# SAFETY RECALL

Date	Number	Release	Page
04.2016	<b>RVXX1603</b>	<b>01</b>	1 (4)

## One Piece Steering Shaft, Replacement

### SAFETY RECALL INFORMATION

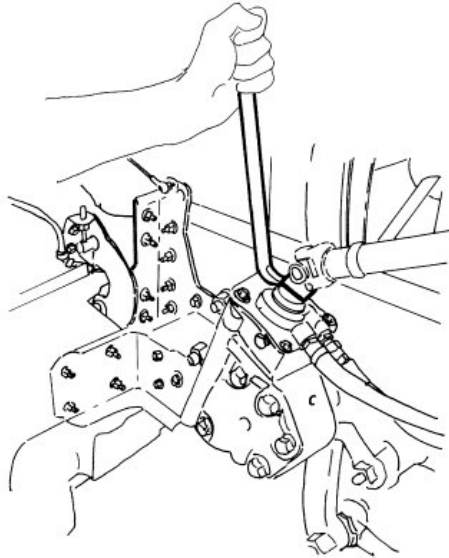
6. Loosen the pinch bolt on the steering shaft upper U-joint. Pry the U-joint off the steering column.
7. Remove the bolts from the shaft boot in the engine compartment. Retain the bolts for reuse.
8. Remove the pinch bolt on the steering shaft lower U-joint. Pry the U-joint off the steering gear.

**CAUTION: Possible equipment damage. Some steering gears have a plastic ring on the input shaft that acts as both a timing ring and a dirt cover. Use care not to damage the ring when prying the U-joint off the steering gear. Failure to use care could damage the plastic ring.**

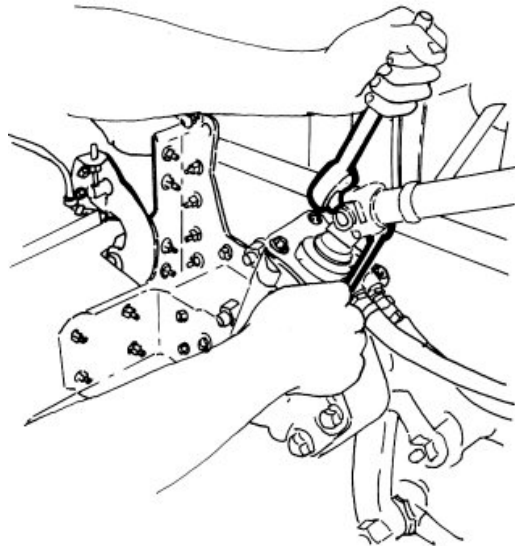
9. Pull the shaft and boot out of the cab from the engine compartment side.
10. Install the new shaft and new boot in from the engine compartment side

**NOTE:** See top image for VNL and bottom image for VNM.

**NOTE:** The greaseable steering shaft (black in color) is shown below. The non-greaseable steering shaft (silver in color) is not shown.

11. Replace the pinch bolts on each end of the steering shaft with a new original equipment bolt.
12. Connect the shaft upper U-joint to the steering column. Tighten the pinch bolt to  $60 \pm 10$  Nm ( $45 \pm 7$  ft-lb). The pinch bolt is perpendicular to the steering column shaft.
13. Ensure the steering wheel is centered.
14. Connect the shaft lower U-joint to the steering gear input shaft. Tighten the pinch bolt to  $60 \pm 10$  Nm ( $45 \pm 7$  ft-lb).
